RE: **2100 Osuna NE**
Grading Plan Engineer's Stamp Date: 1/2/18
Drainage Report Engineer's Stamp Date: 12/28/17
Drainage File: E16D001

RE: **2100 Osuna NE**
Grading Plan Engineer's Stamp Date 11/15/17
Drainage Report Engineer's Stamp Date: missing
Drainage File: E16D001

REVISED
DRAINAGE REPORT

2100 Osuna NE
Albuquerque, New Mexico

UPLAND FLOW MAP

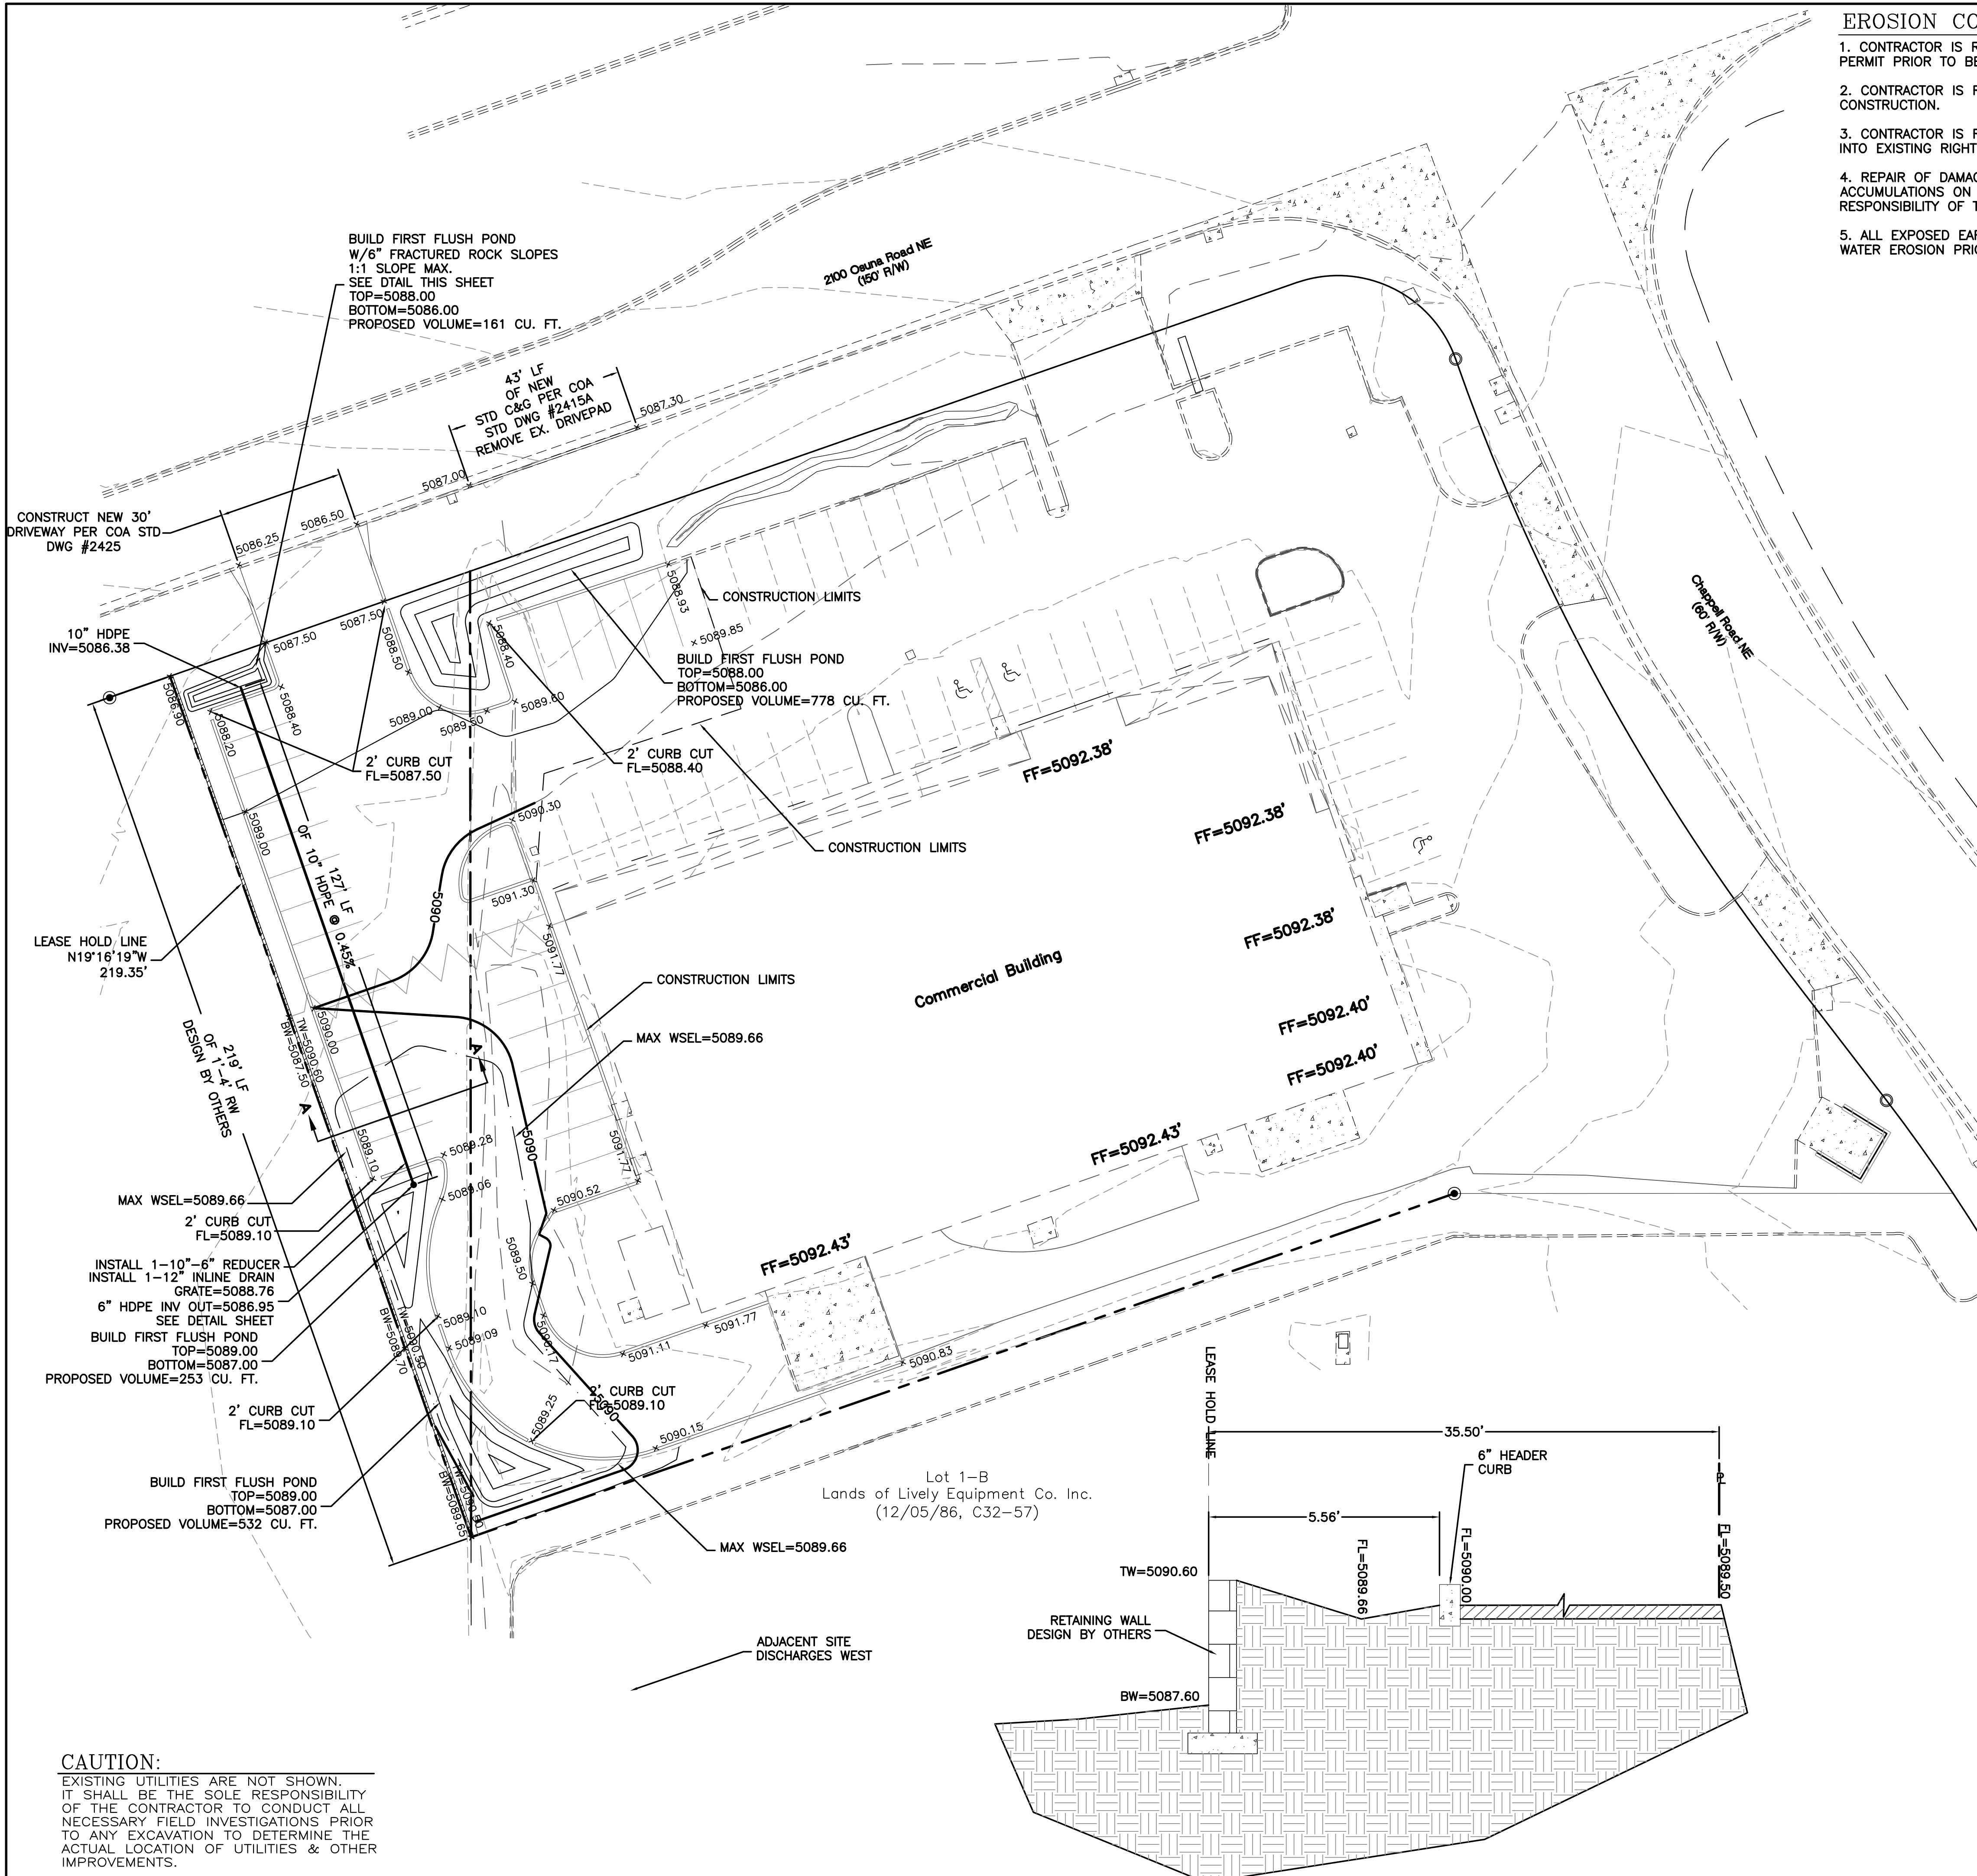
1. How does Lot 1B (to the south of this site) drain? It appears to drain to its NE corner and onto the SW corner of your site. Provide additional discussion regarding this. If there are

off-site flows, these will need to be routed across your site as well. Include the topo figure in the Drainage Report to support this discussion.

We have added map and updated report
Grading Plan.

SECTION A-A

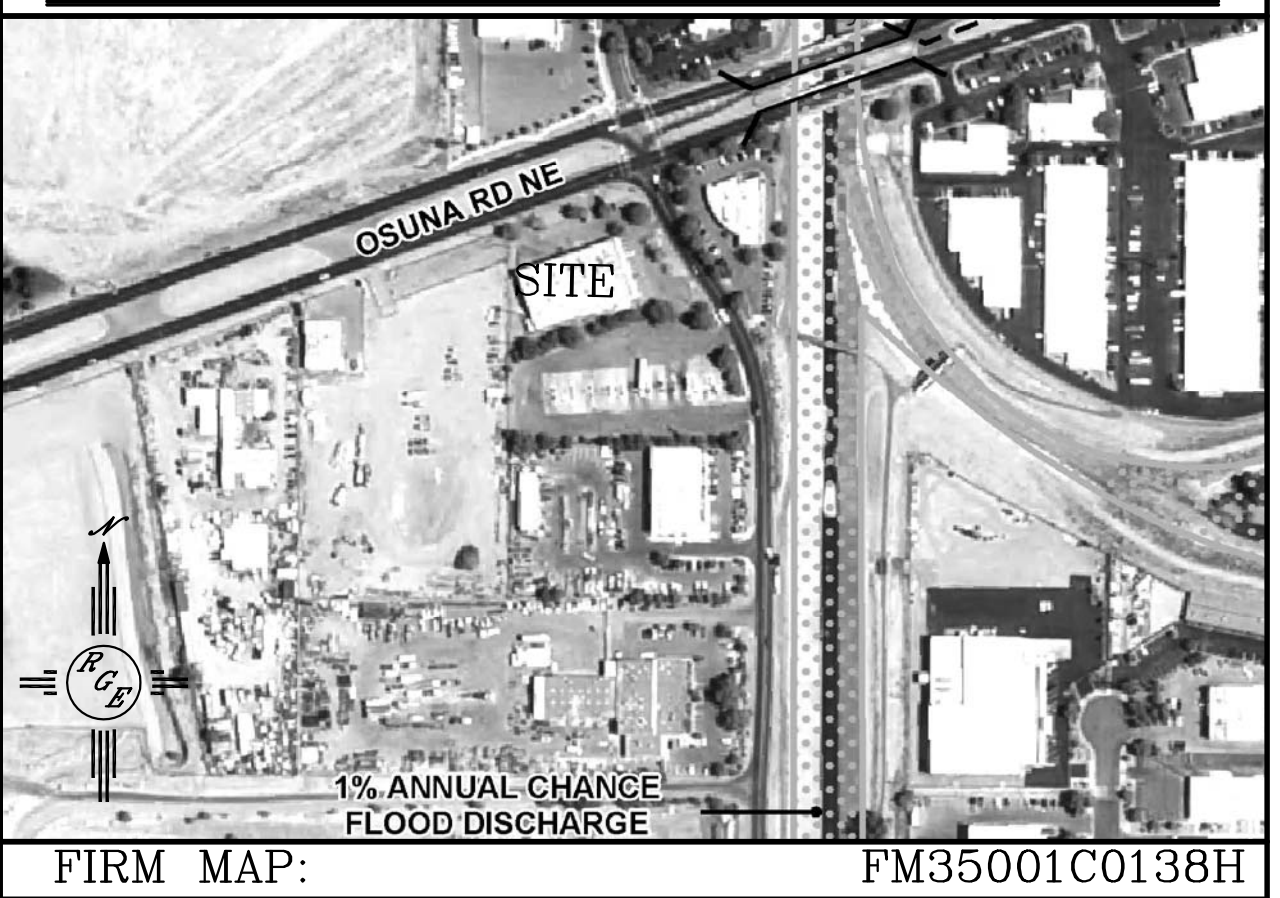
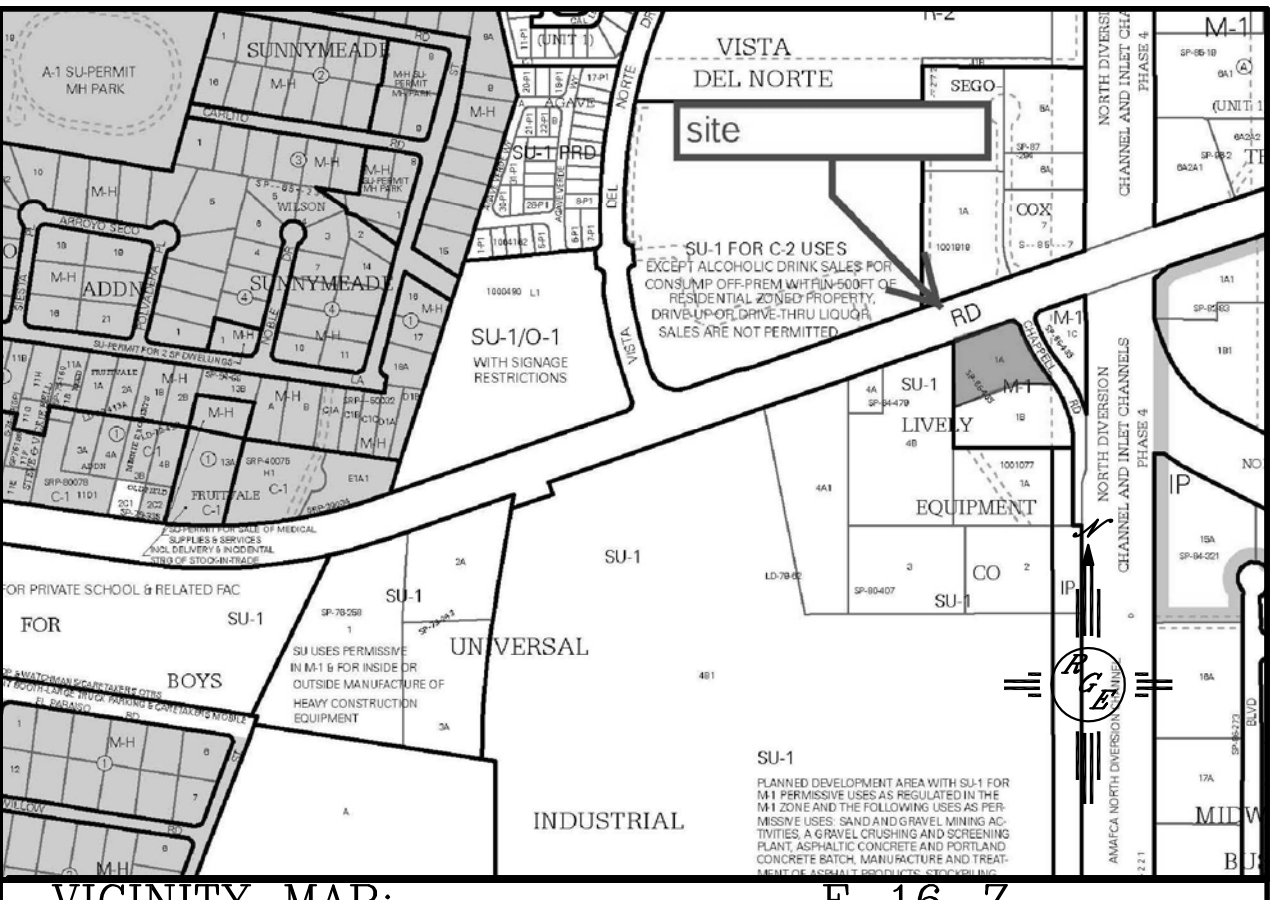
1. Provide a section view through the retaining wall (including dimensions, lease line, and basis of establishing the lease line).

We have added the section and basis of leasehold line
